BEFORE THE
Federal Communications Commission
Washington, DC 20554

LightSquared Subsidiary LLC

File No. SAT-MOD-
20101118-00239

Comments by Charles W. Rhodes

Figure 1. Simulated spectrum of 10MHz LTE signal 1526-1536 MHz

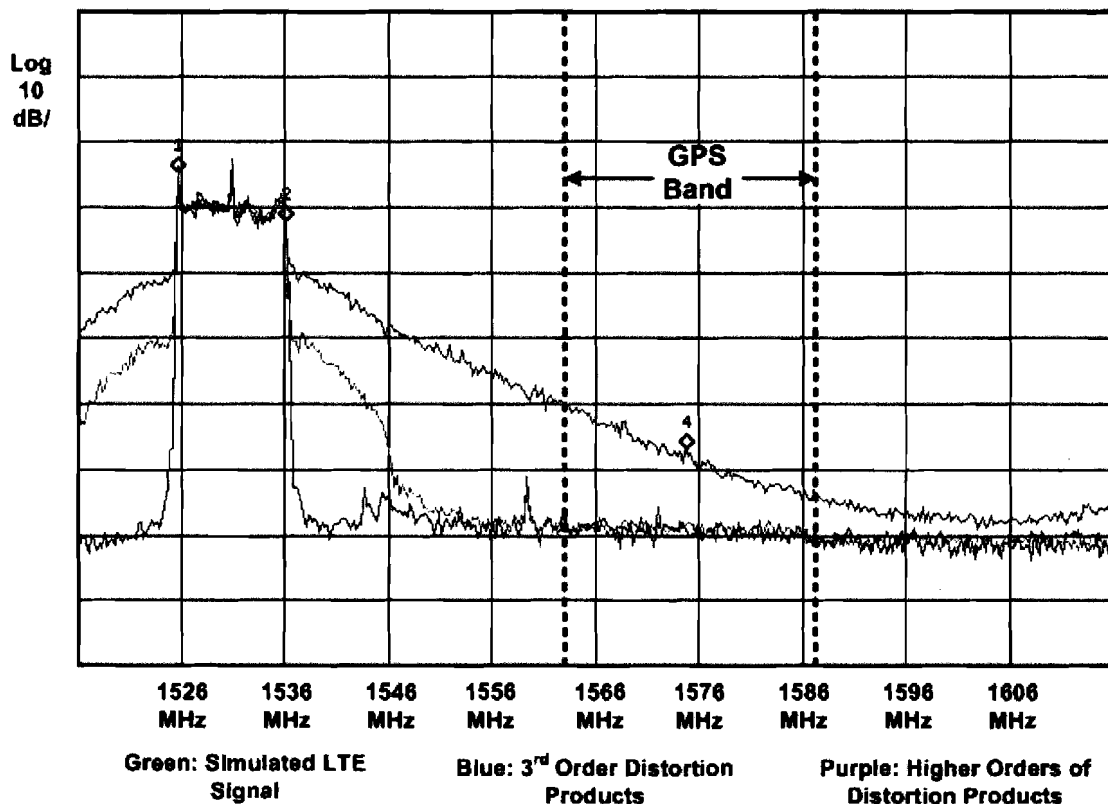
I believe that the interference reported by the TWG for two 5 MHz LTE signals in the MSS Band was primarily due to third order inter-modulation products generated by that pair of LTE signals. The recent proposal by LightSquared to initially radiate only one LTE signal in the MSS Band (see above) will not result in third order distortion products which fall within the GPS receiver passband. However, my simulation has shown that there will be higher order distortion products which will fall within the GPS Band as shown in my Figure 1 attached.

I have also simulated the single ten MHz wide LTE signal in the MSS Band from 1526 MHz to 1536 MHz to see if it might also cause interference to GPS reception as shown in Figure 1.

This interfering signal would overload many GPS receiver input transistors and they will generate higher order distortion products some of which fall in the GPS Band as shown in Figure 1.

Marker # 1: 1526 MHz (simulated) Marker # 2: 1536 MHz (simulated) and Marker # 4: 1575 (simulated). .

What this simulation demonstrates is that the noise floor in the simulated GPS band is from 8 to 18 dB above the instrumentation noise floor. If we take the average of 13 dB across the GPS Band, that is the jamming effect of this signal. This 13 dB increase in the noise floor across the GPS Band is not the only factor that will cause jamming of GPS reception. The other cause and it could be the more significant cause is called de-sensitization. This is another odd order distortion product but it applies to all signal frequencies. The undesired signal received power can exceed that of the GPS signal by 100 dB. It is most unlikely that any known transistor will not suffer de-sensitization when two signals as different in power as this are present. Even with a filter between the antenna and the RF amplifier transistor, the power difference between the LightSquared signal and the GPS signals is so great that some de-sensitization will be experienced.
